TOPIC STATEMENT OF COMMON GROUND – LIVING CONDITIONS RfR5

APPEAL REFERENCE APP/X3540/W/19/3242636

APPELLANT Capital Community Developments Ltd

Land North Of Gardenia Close And Garden Square Rendlesham Suffolk.

It is completely unclear what issues the LPA has in their 'Area E'.

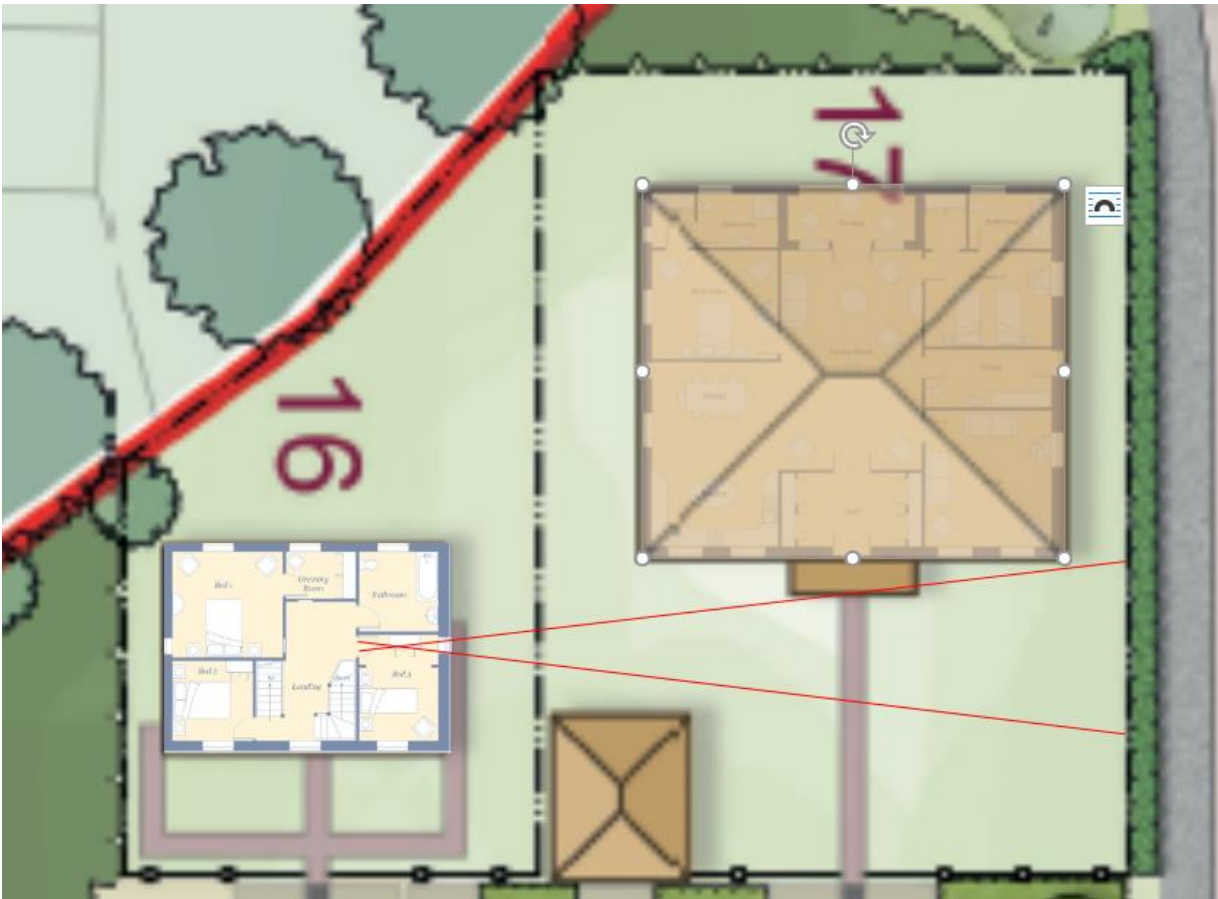
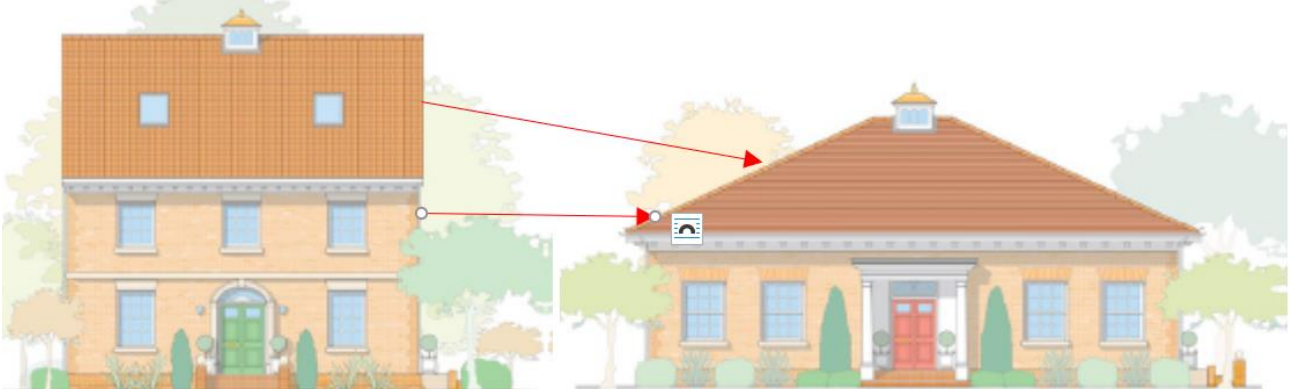
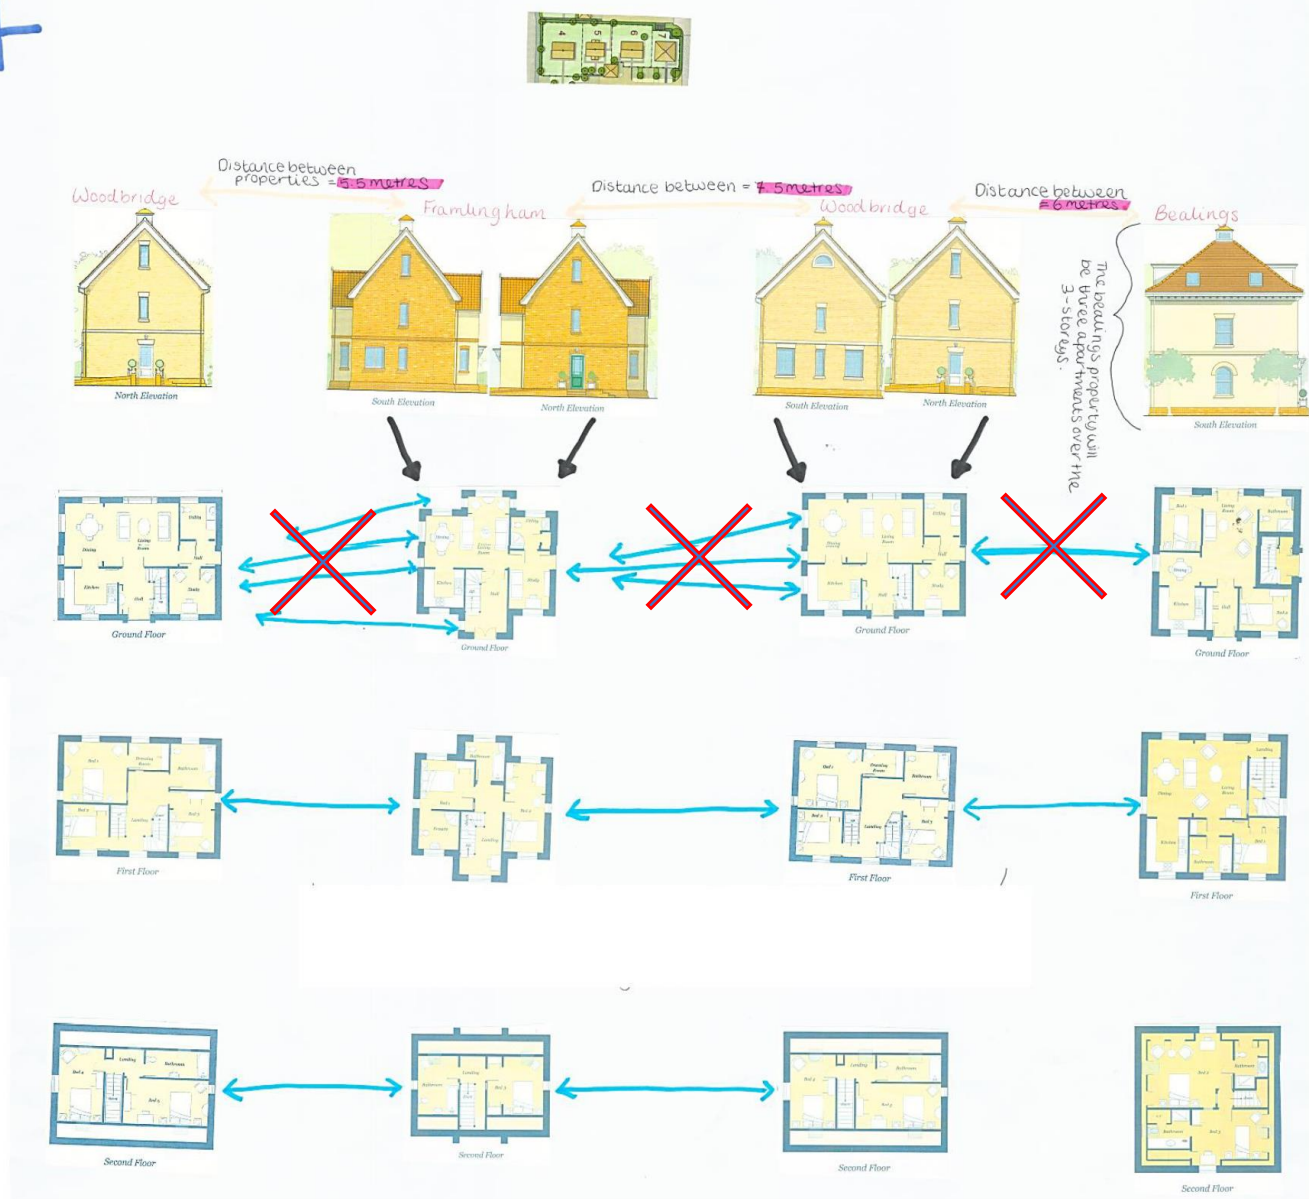
If the LPA is attempting to show that the Woodbridge somehow dominates or overlooks the Deben then, as with the other example areas above, they have failed to understand that the two properties are offset from each other. Therefore, from the Woodbridge windows at first and second floor on the northern elevation, even if viewed from a very obscure angle, the only real view is of the bungalow's roof.

As can be seen below the view from the first and second floor northern elevations windows of the Woodbridge through the narrow slot windows pass by the front of the Deben Bungalow:

Whilst it is wholly unclear what issues the LPA is trying to highlight here; the fact remains that the properties have not been properly aligned. The occupants of the Woodbridge cannot see around corners.

F

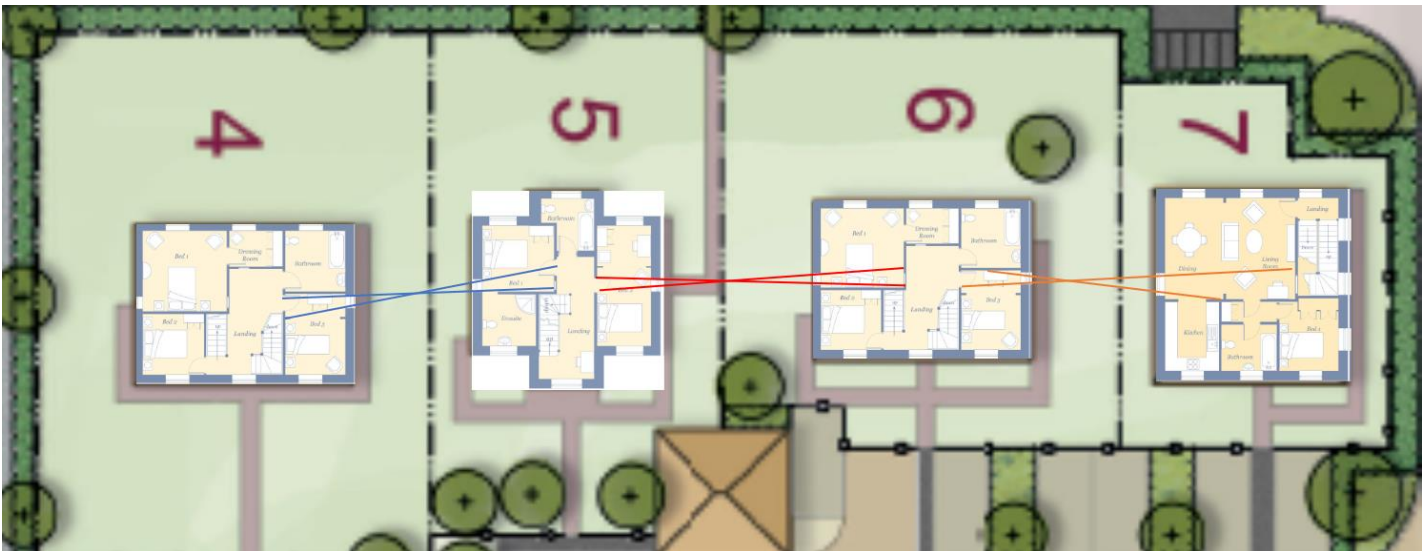
Of the 3x first floor inter-relationships between the various properties below the following comments are generic to all:

- The angles are very tight because the windows are narrow, therefore the actual proportion of the rooms in which any views might be possible is very small.
- The windows are narrow and are not the principle windows and thus could have been obscure glazed had the LPA have requested this.

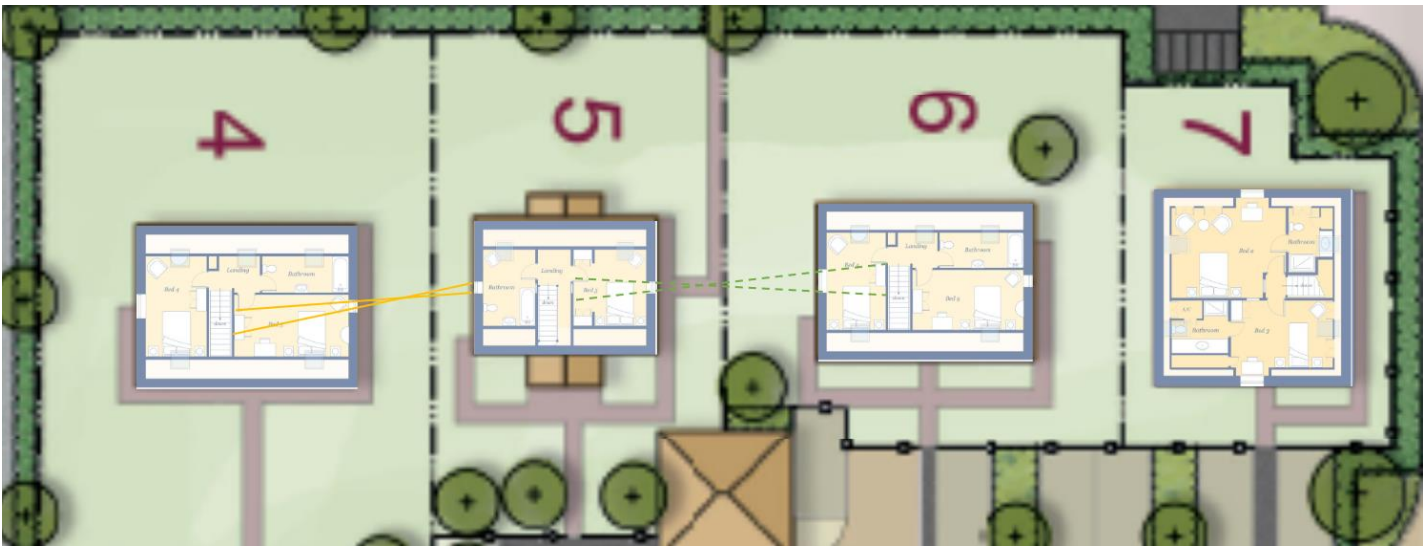
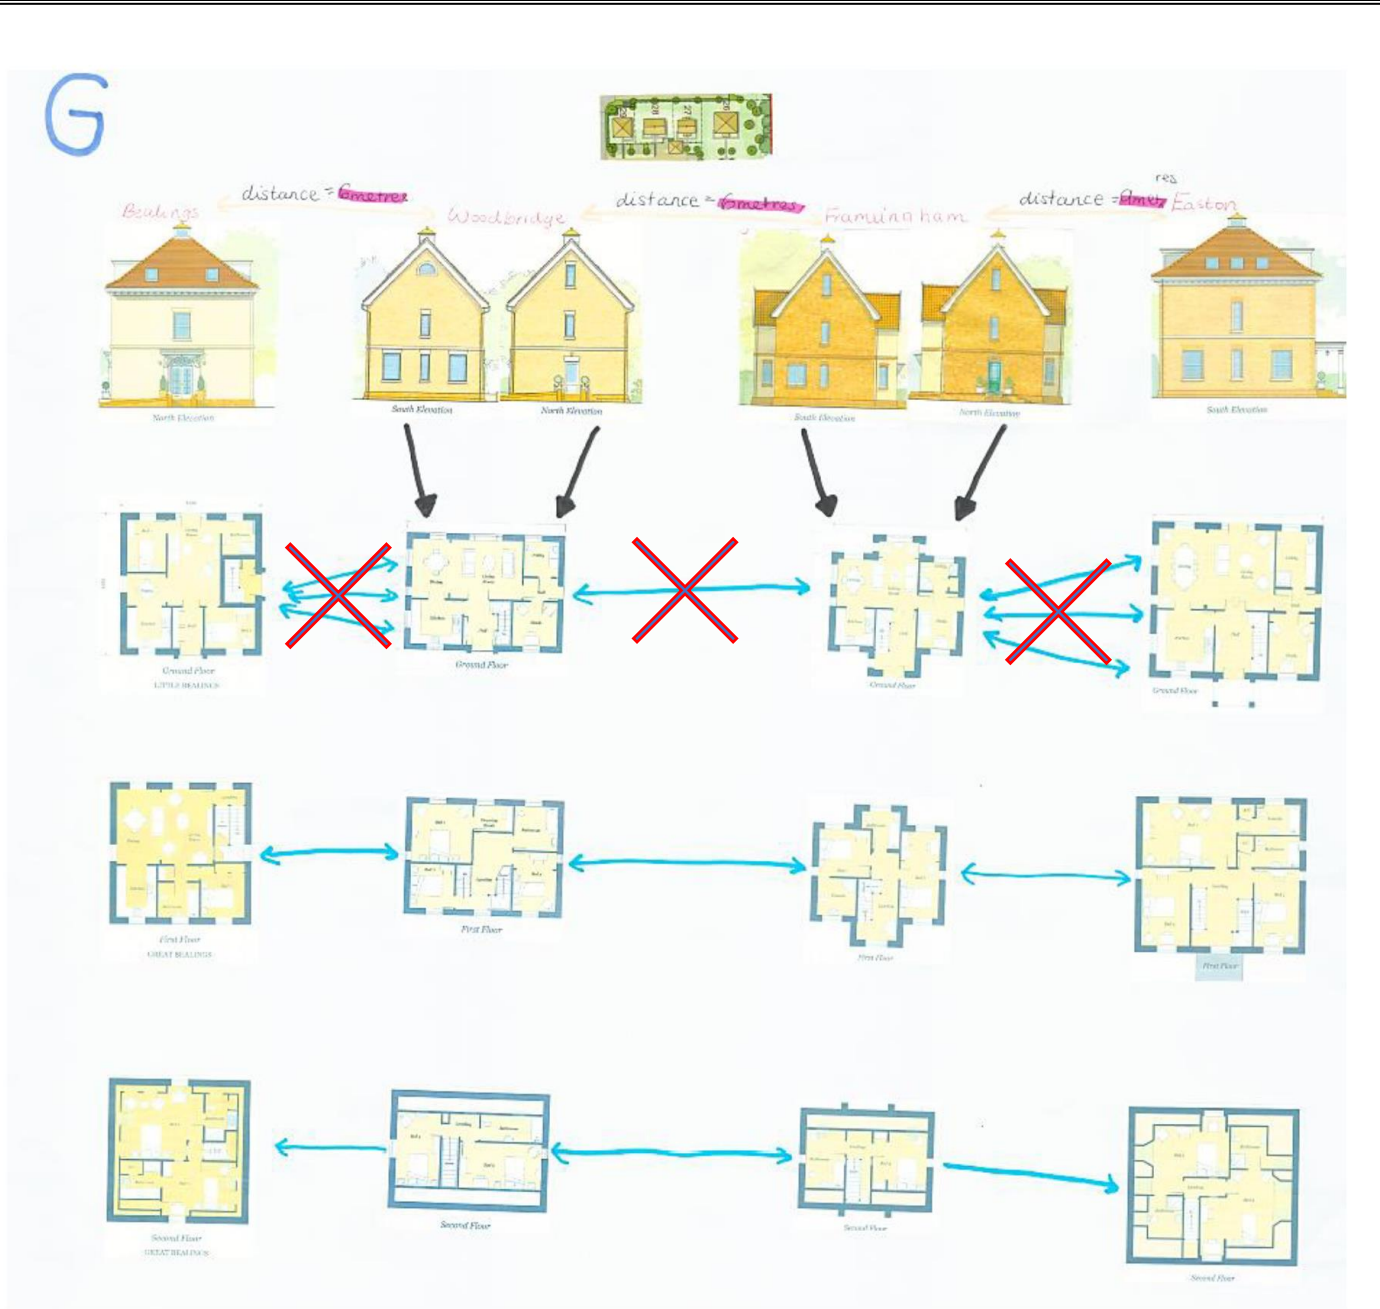
Of the 2x second floor inter-relationships which the LPA refer to in their evidence, we have the following comments:

- The relationship between Plot 4 (Woodbridge) and Plot 5 (Framlingham) is acceptable because the northern elevation window at first floor in the Woodbridge is a bathroom and should have been assumed by the LPA to be obscure glazed.
- As set out in other examples above the 1x potential overlooking between plots 5 (Framlingham) and 6 (Woodbridge) is acceptable of the near impossible likelihood of a person standing in the second floor bedroom of the Woodbridge and being able to look over the lip of the above-head height window in the southern elevation of the Woodbridge (green dashed lines).

None of the 13x inter-relationships referred to in the LPAs evidence stand up to scrutiny. There are no overlooking issues which either 'trip' planning policy or cannot otherwise be overcome with simple planning controls.
